| INFORMATION AVAILABLE TO PREPARE DRAWINGS            |
|------------------------------------------------------|
| ARCHITECTURAL DRAWINGS NOTED ADDENDUM #4 – 9/16/2019 |

| NO. | REVISION/ISSUED | DATE       |
|-----|-----------------|------------|
| 1   | 1ST SUBMITTAL   | 01/27/2020 |

| PROJECT NAME & LOCATION:<br>CHRISTIAN FELLOWSHIP | 208 EAST BROADWAY<br>COLUMBIA, MO 65203 | SHEET TITLE:<br>COVER SHEET |

**1 WINDOW TYPE C ELEVATION**  
TUBELITE T14000 2" X 4-1/2"  
EXTERIOR STOREFRONT  
ARCH. REF.: C/A5.1

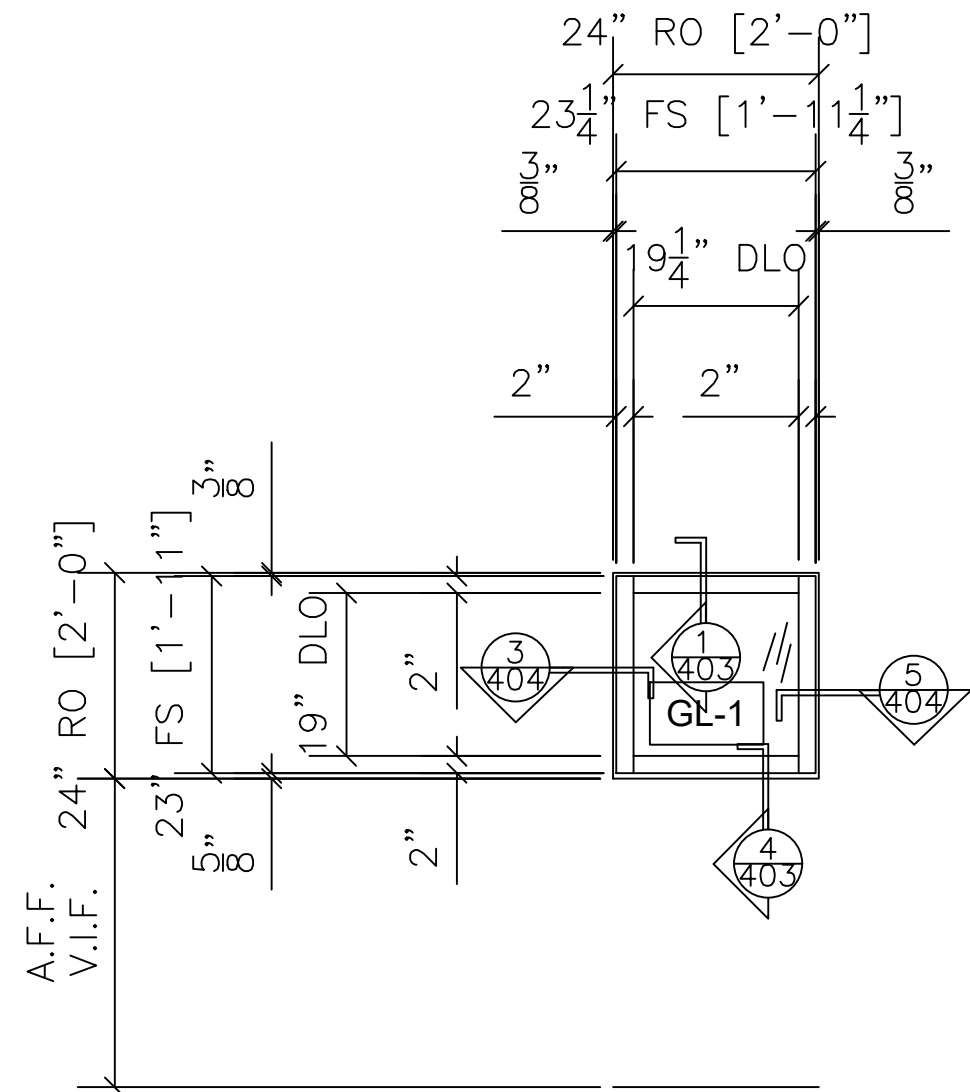
ARCHITECT NOTE:  
NO FRAME ELEVATION PROVIDED ON  
DRAWINGS. PLEASE ADVISE & VERIFY ALL  
LAYOUTS & DIMENSIONS SHOWN.

**2 WINDOW TYPE D ELEVATION**  
TUBELITE T14000 2" X 4-1/2"  
EXTERIOR STOREFRONT  
ARCH. REF.: D/A5.1

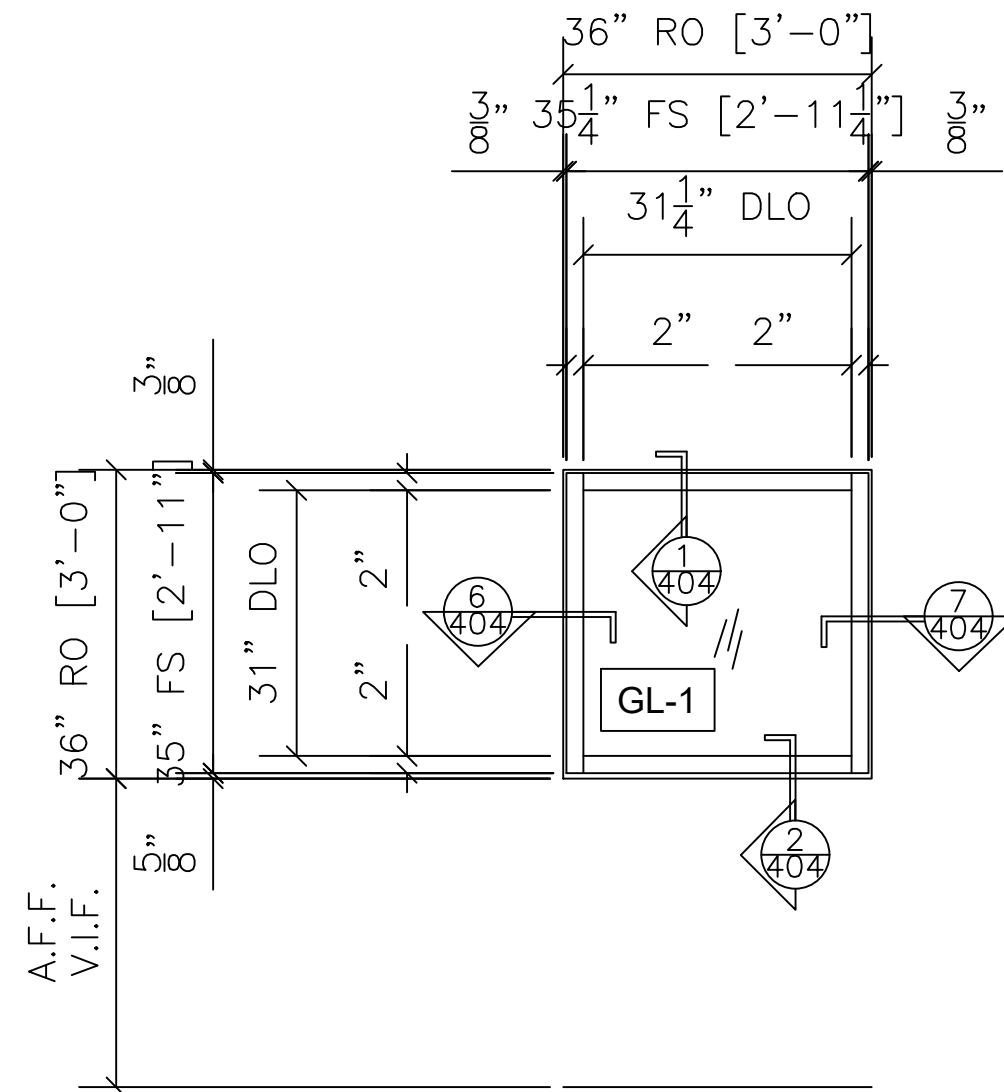
ARCHITECT NOTE:  
CANNOT LOCATE THIS FRAME ON PLANS  
OR ELEVATIONS. PLEASE ADVISE OF  
LOCATION(S).

| 4 WEST VESTIBULE FRAME 4 ELEVATION |                             |                    |                    |

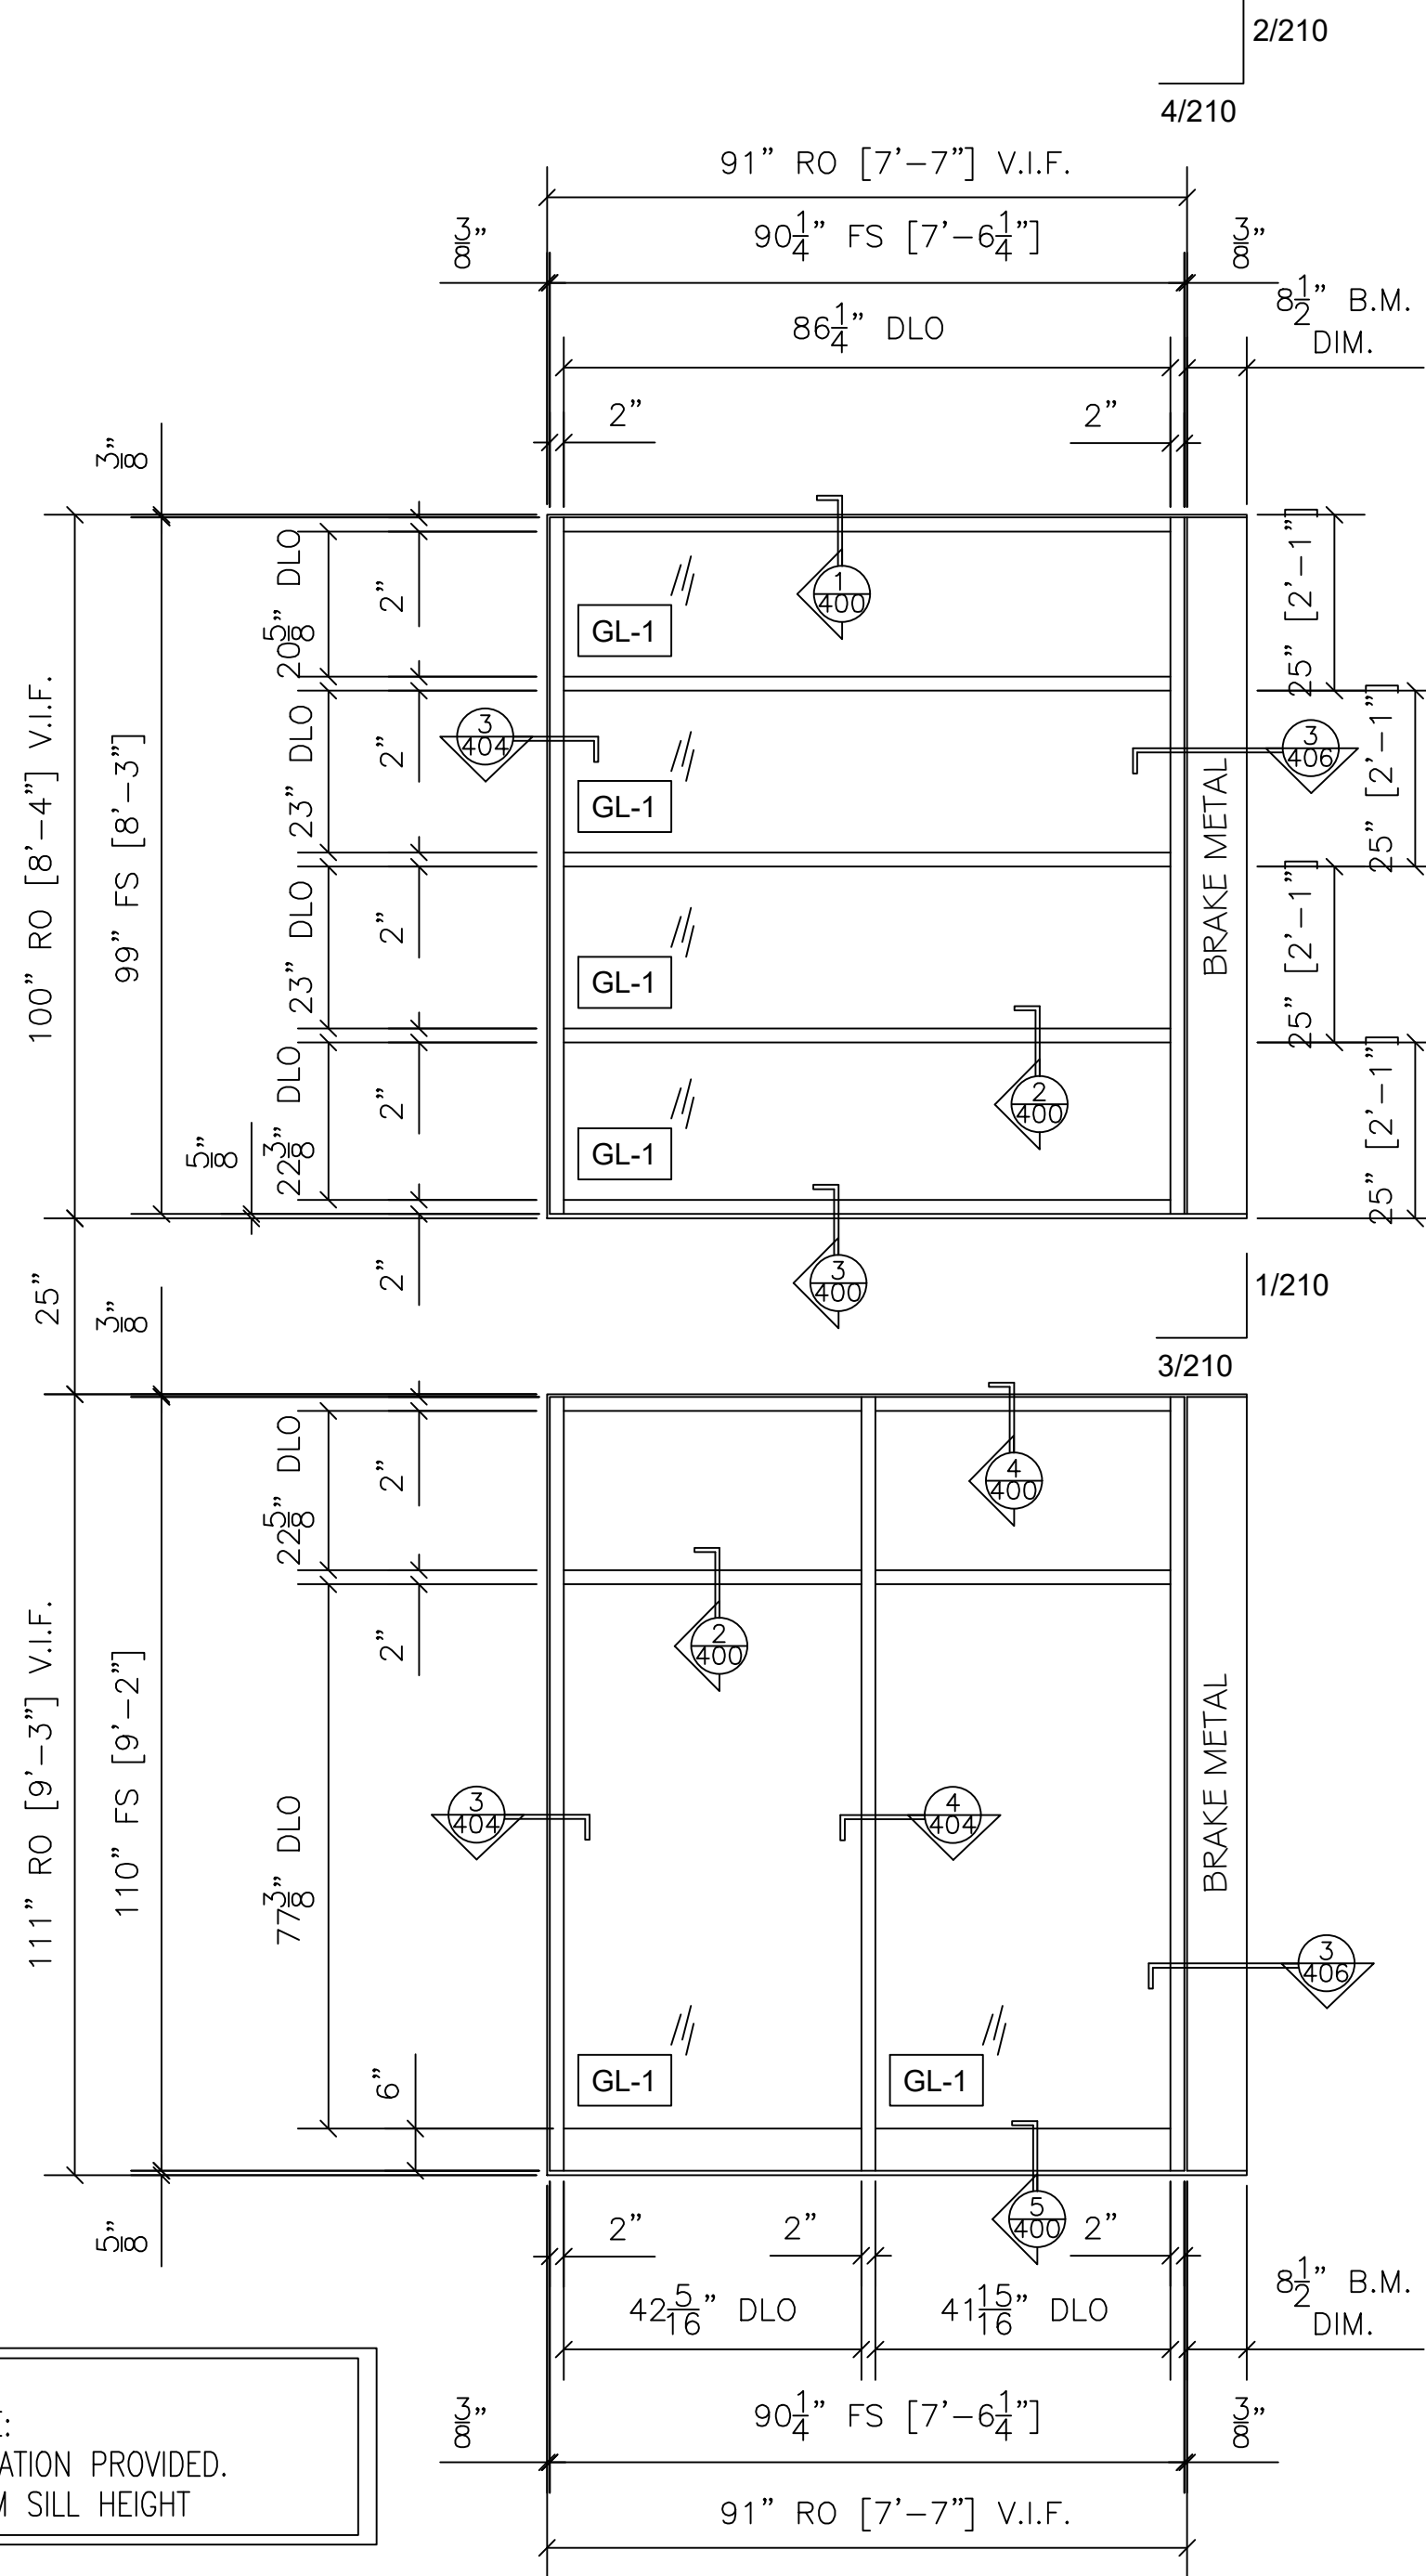
ARCHITECT NOTE:  
NO FRAME ELEVATION PROVIDED ON  
DRAWINGS. PLEASE ADVISE & VERIFY ALL  
LAYOUTS & DIMENSIONS SHOWN.

ARCHITECT NOTE:  
NO FRAME ELEVATION PROVIDED.  
PLEASE CONFIRM SILL HEIGHT

| 2 WEST VESTIBULE FRAME 2 ELEVATION |                             |                   |                    |

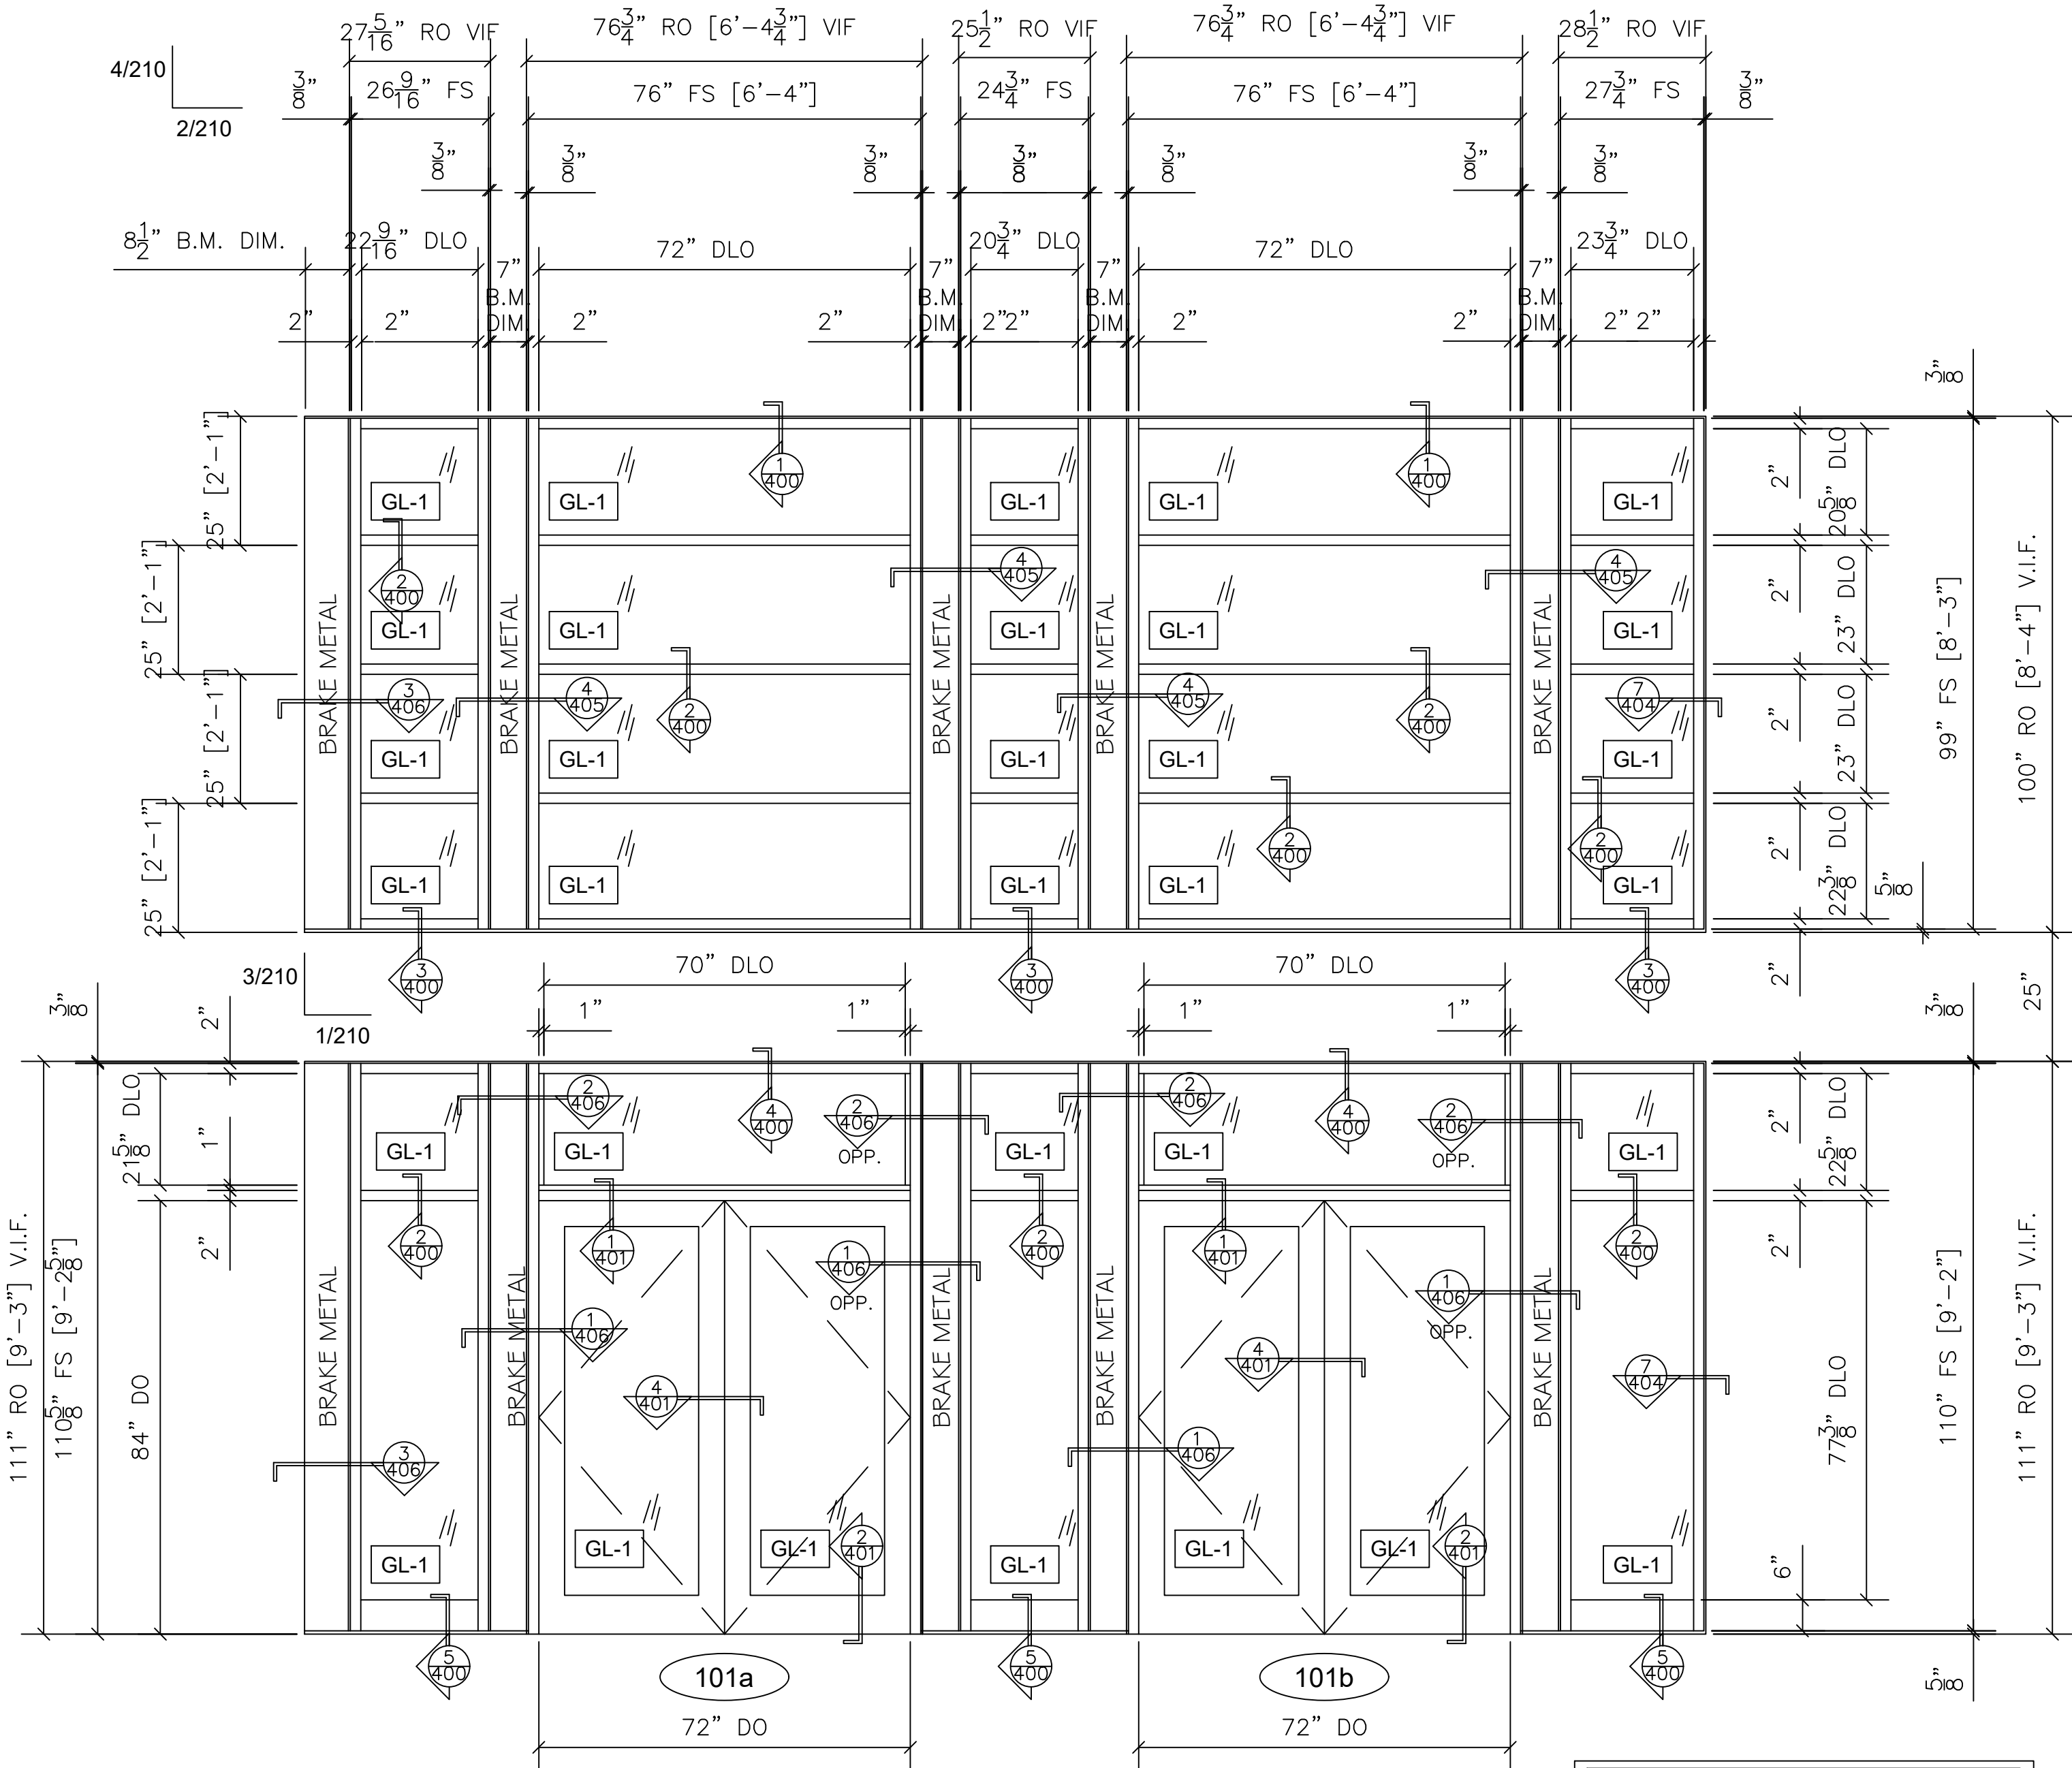
ARCHITECT NOTE:  
NO FRAME ELEVATION PROVIDED ON  
DRAWINGS. PLEASE ADVISE & VERIFY ALL  
LAYOUTS & DIMENSIONS SHOWN.

ARCHITECT NOTE:  
NO FRAME ELEVATION PROVIDED ON  
DRAWINGS. PLEASE ADVISE & VERIFY ALL  
LAYOUTS & DIMENSIONS SHOWN.

ARCHITECT NOTE:  
NO FRAME ELEVATION PROVIDED.  
PLEASE CONFIRM SILL HEIGHT
